Title of Change:	Update to FPCN23290X - SMAF Rectifiers Manufacturing Site Change.	
Proposed First Ship date:	29 Jul 2020 or earlier if approved by customer	
Contact Information:	Contact your local ON Semiconductor Sales Office or Benjo.Rulona@onsemi.com	
PCN Samples Contact:	Contact your local ON Semiconductor Sales Office or <PCN.samples@onsemi.com>. Sample requests are to be submitted no later than 30 days from the date of first notification, Initial PCN or Final PCN, for this change. Samples delivery timing will be subject to request date, sample quantity and special customer packing/label requirements.	
Additional Reliability Data:	Contact your local ON Semiconductor Sales Office or songyong.sim@onsemi.com	
Type of Notification:	This is a Final Product/Process Change Notification (FPCN) sent to customers. FPCNs are issued 90 days prior to implementation of the change. ON Semiconductor will consider this change accepted, unless an inquiry is made in writing within 30 days of delivery of this notice. To do so, contact PCN.Support@onsemi.com

Package Outline Dimension Comparison

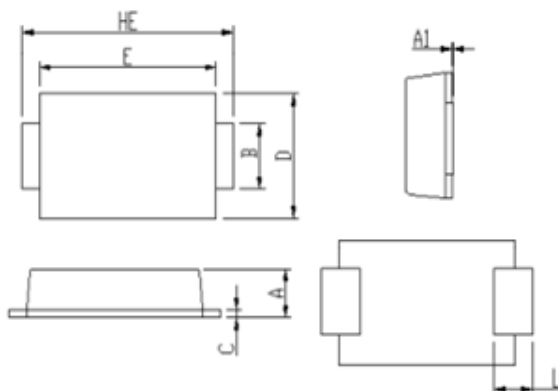
Marking of Parts/ Traceability of Change:	Assembly Plant Code Marking Change from J to g	
Change Category:	Wafer Fab Change, Assembly Change	
Change Sub-Category(s):	Manufacturing Site Transfer	
Sites Affected:		
ON Semiconductor Sites	External Foundry/Subcon Sites	
None	Good-Ark, China	
	Panjit International Inc., Taiwan	
Description and Purpose:		
<p>This is an Update Notification to FPCN23290X to include The POD Change and Package Outline Comparison Details as it was inadvertently excluded in the original PCN.</p> <p>FPCN23290X was originally issued in April with details below:</p> <p>As part of ON Semiconductor's effort to secure available capacity and meet customer's need of a reliable source for Rectifiers in SMAF package, qualification of Good-Ark located in Suzhou, China has been undertaken.</p> <p>This new sourcing is intended to meet consistent supply and service and to prevent supply disruption to our customers.</p> <p>These products are currently assembled and tested in a manufacturing site located in Taiwan. A comparison of the differences between the current and new sites' built parts are presented in the table below. Please note that there is also a slight change in the Package Outline Dimensions (POD):</p>

Before Change Description	After Change Description
Wafer Fab	Pynmax, Taiwan	Suzhou Good-Ark Electronics Co. Ltd
Assembly Site	Panjit International Taiwan	Suzhou Good-Ark Electronics Co. Ltd
Topmetal/Backmetal	Au	Ni
Green Molding Compound	ELER-8-500C-S	EK1700GH/SP-G300
POD Change	A	B

Package (mm)	A	B	C	D	E	L	HE
Current (A)	0.9~1.1	1.60~1.9	0.1~0.25	2.3~2.7	3.6~4.0	0.5~0.95	4.4~5.0
New (B)	No Change	1.25~1.9	No Change	No Change	3.6~4.3	No Change	4.4~5.2
